DOCUMENT 00 90 00
ADDENDUM

ADDENDUM No.: 4

DATE: March 6, 2025

RE: WESTERN TECHNICAL COLLEGE
AUTOMOTIVE TECHNOLOGY CENTER ADDITION AND REMODEL
2721 LARSON ST.
LA CROSSE, WISCONSIN 54603
PROJECT NO. 24061

1 FINISH FLOOR PLAN - SEGMENT B
1/8" = 1'-0"

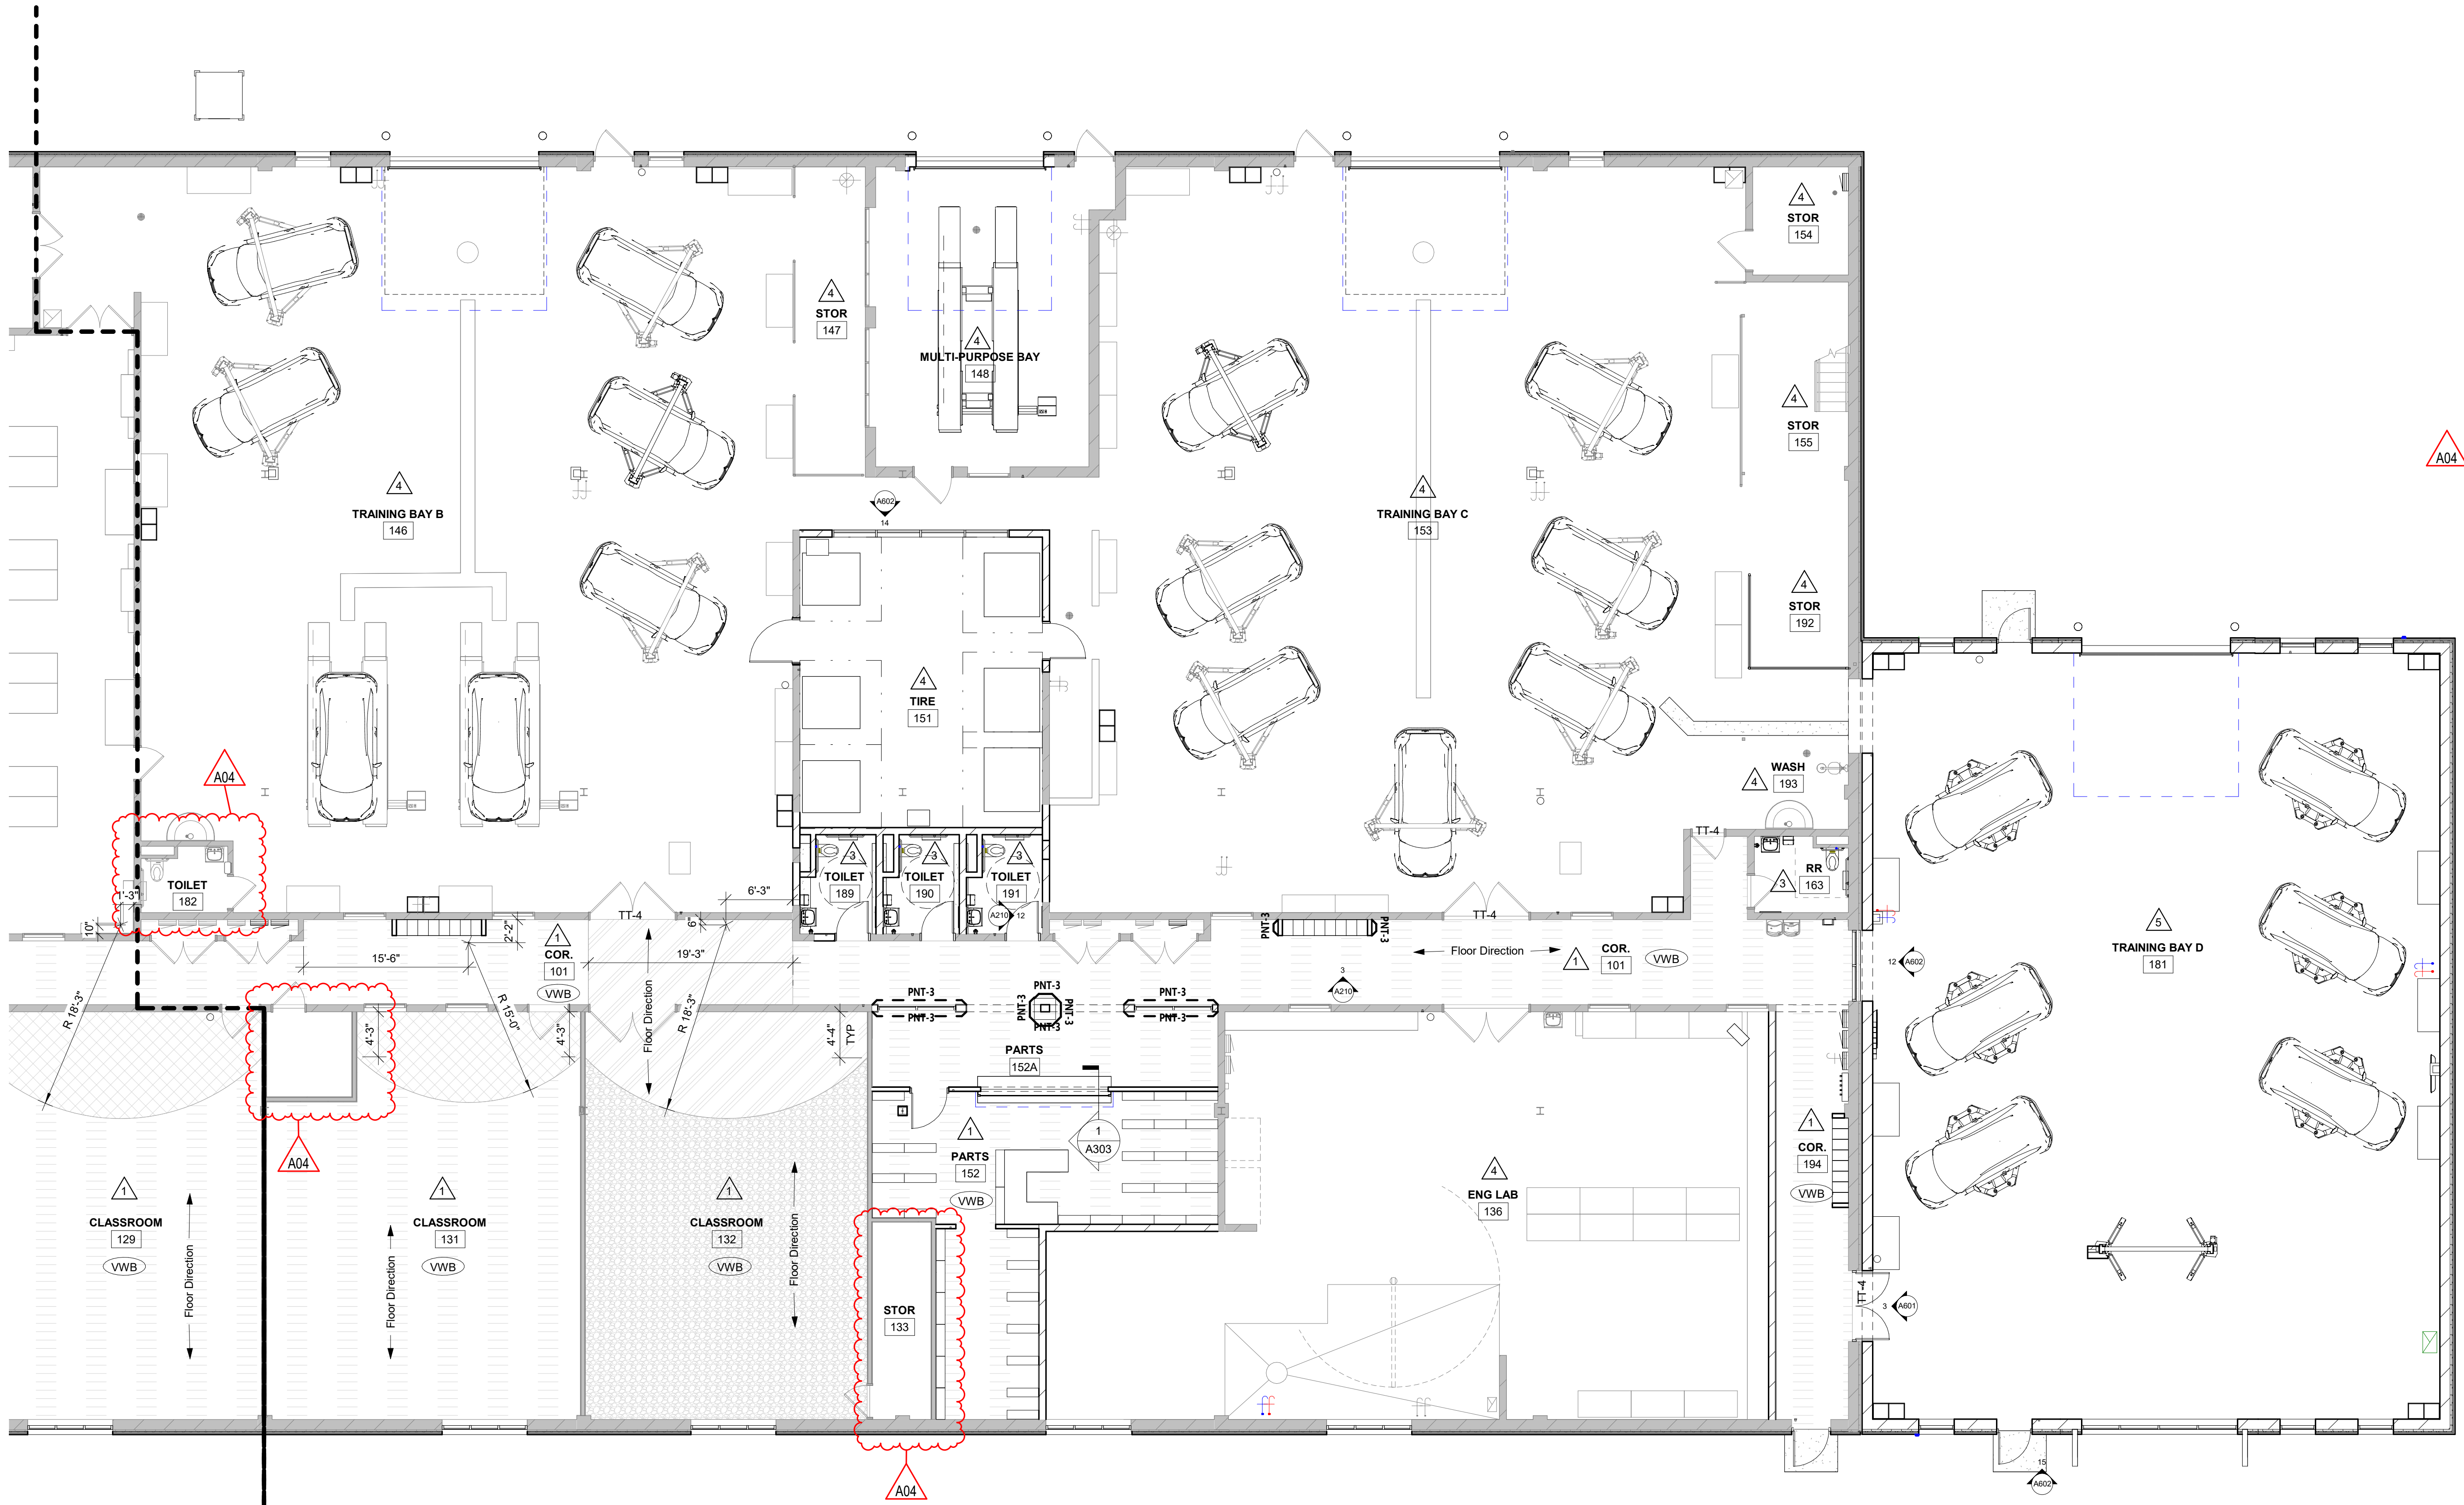
- b. Added a description for Room Finish Remarks item 3.
 - c. Revised flooring scope in rooms, 121, 122, 123, 127, & 128.
18. Sheet ID102 FINISH FLOOR PLANS – SEGMENT A 30"x42"

- a. See the revised sheet included in this addendum. Disregard the previous version.
 - b. Added a description for Room Finish Remarks item 3.
 - c. Revised flooring scope in rooms, 130 & 133.

17 CANOPY CONNECTION TO VESTIBULE HSS
SCALE: N.T.S.

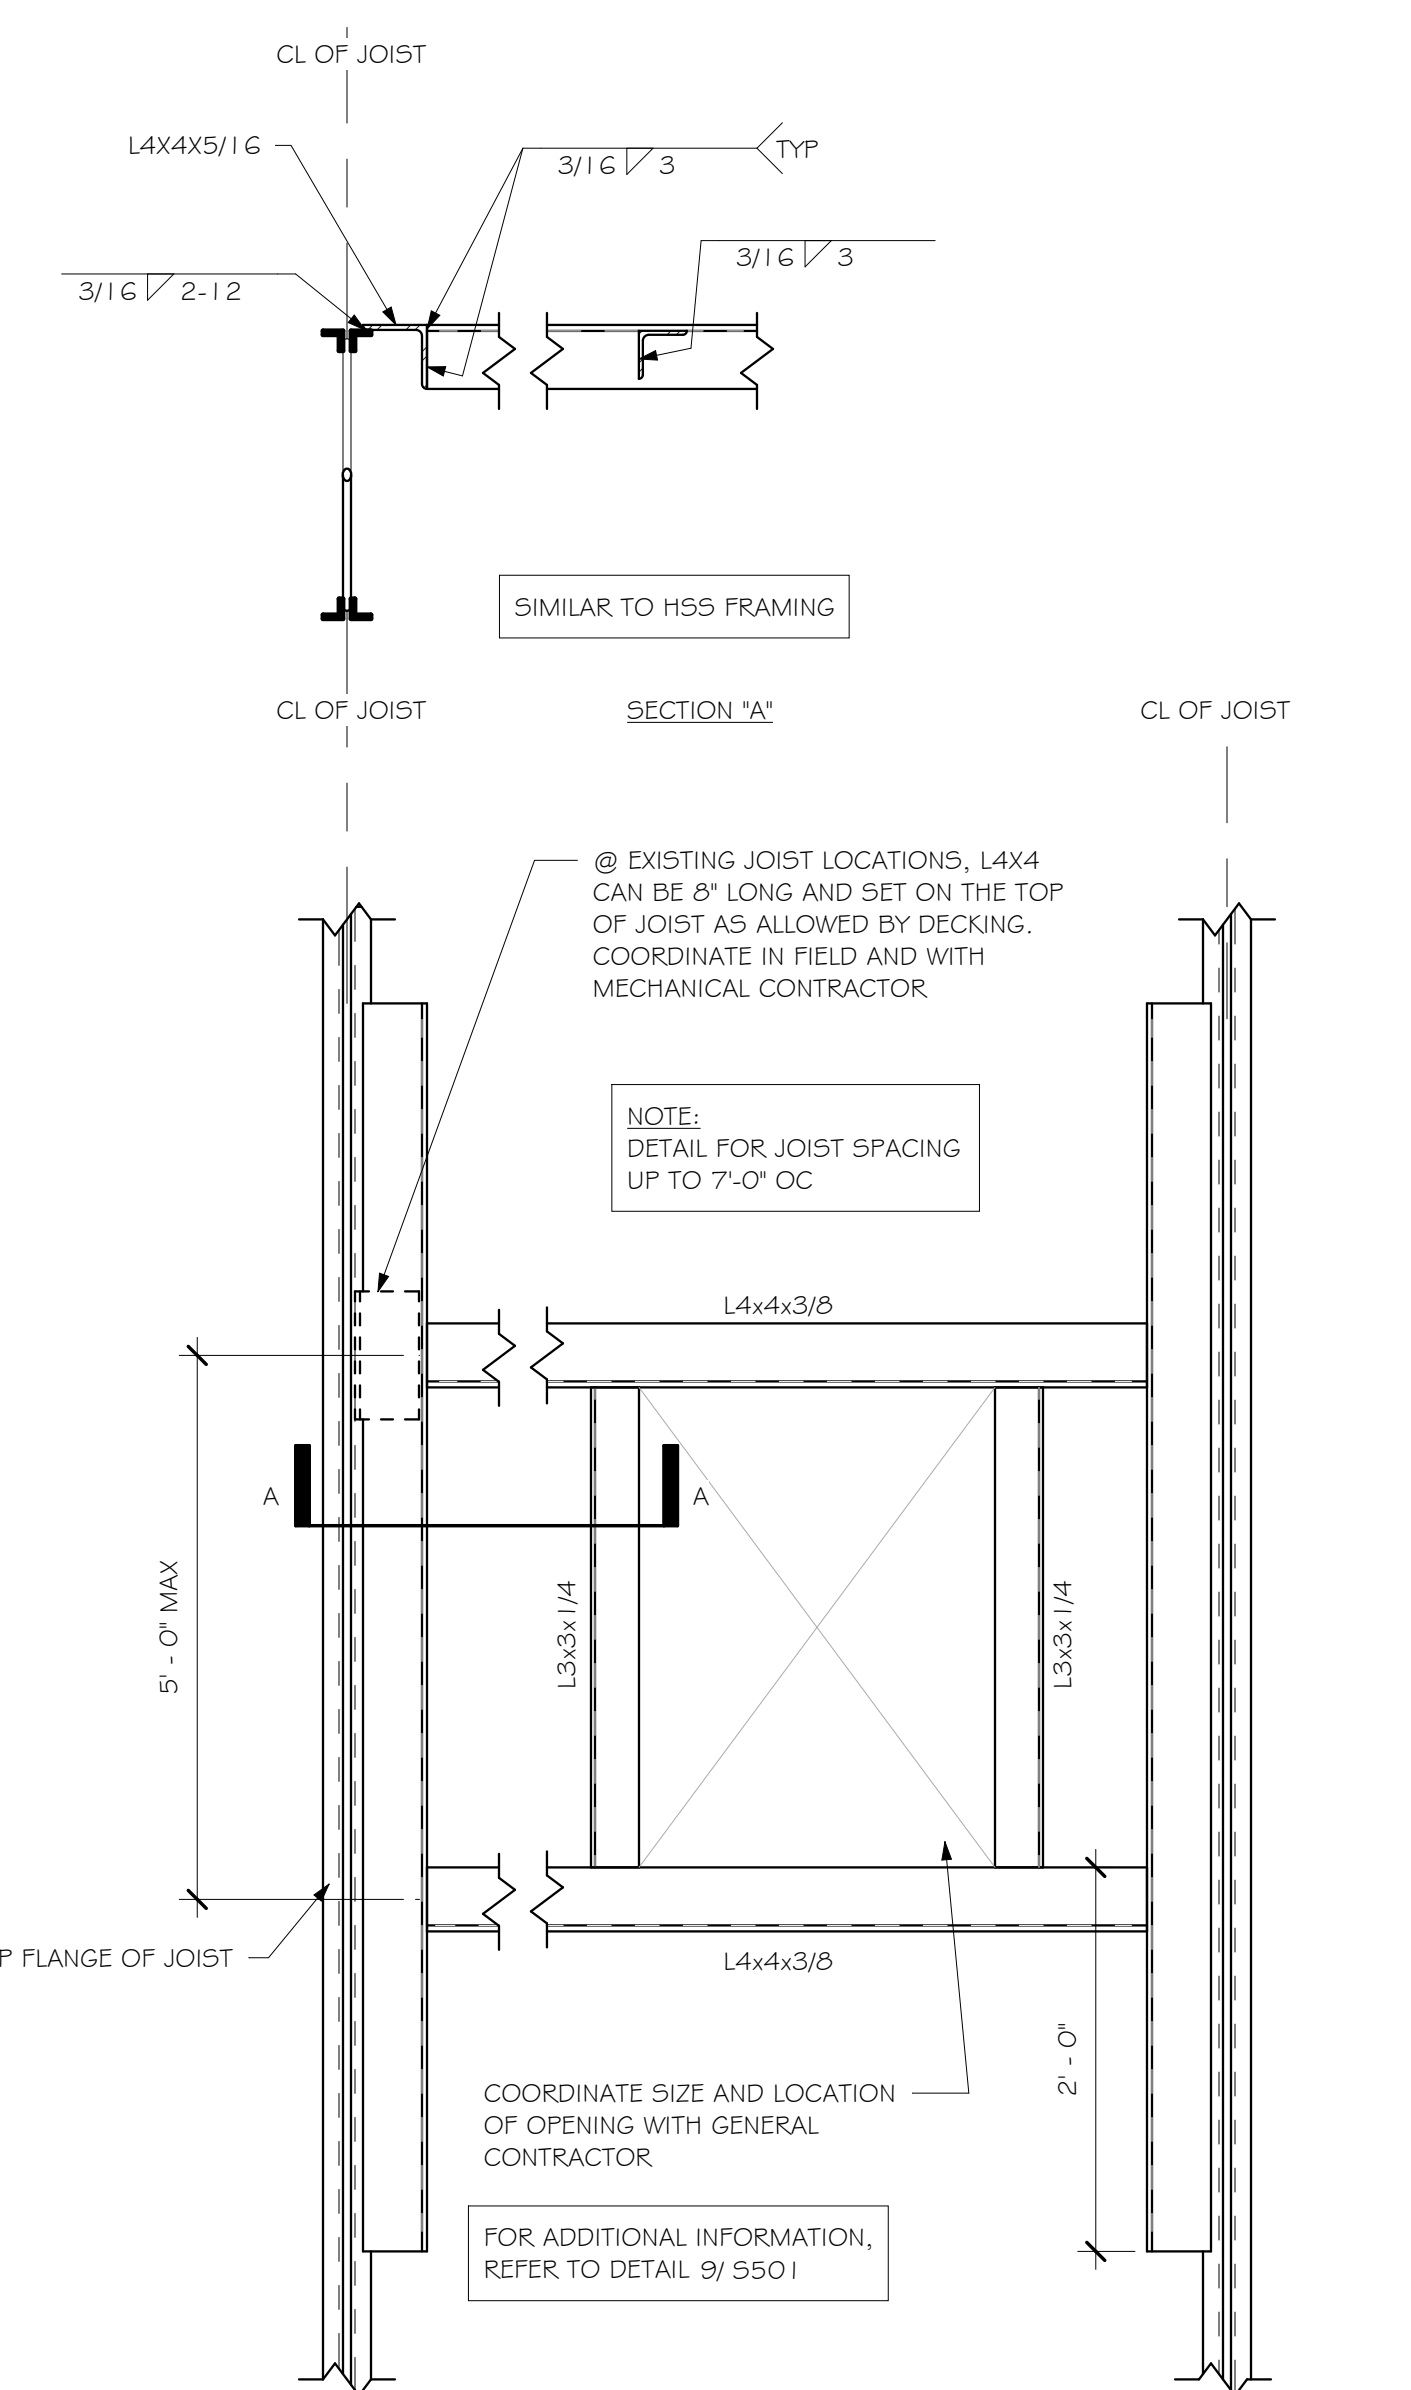
20. Sheet S501 STEEL DETAILS & SCHEDULES 30"x42"
 - a. See the revised sheet included in this addendum. Disregard the previous version.
 - b. Added detail 17 on S501.
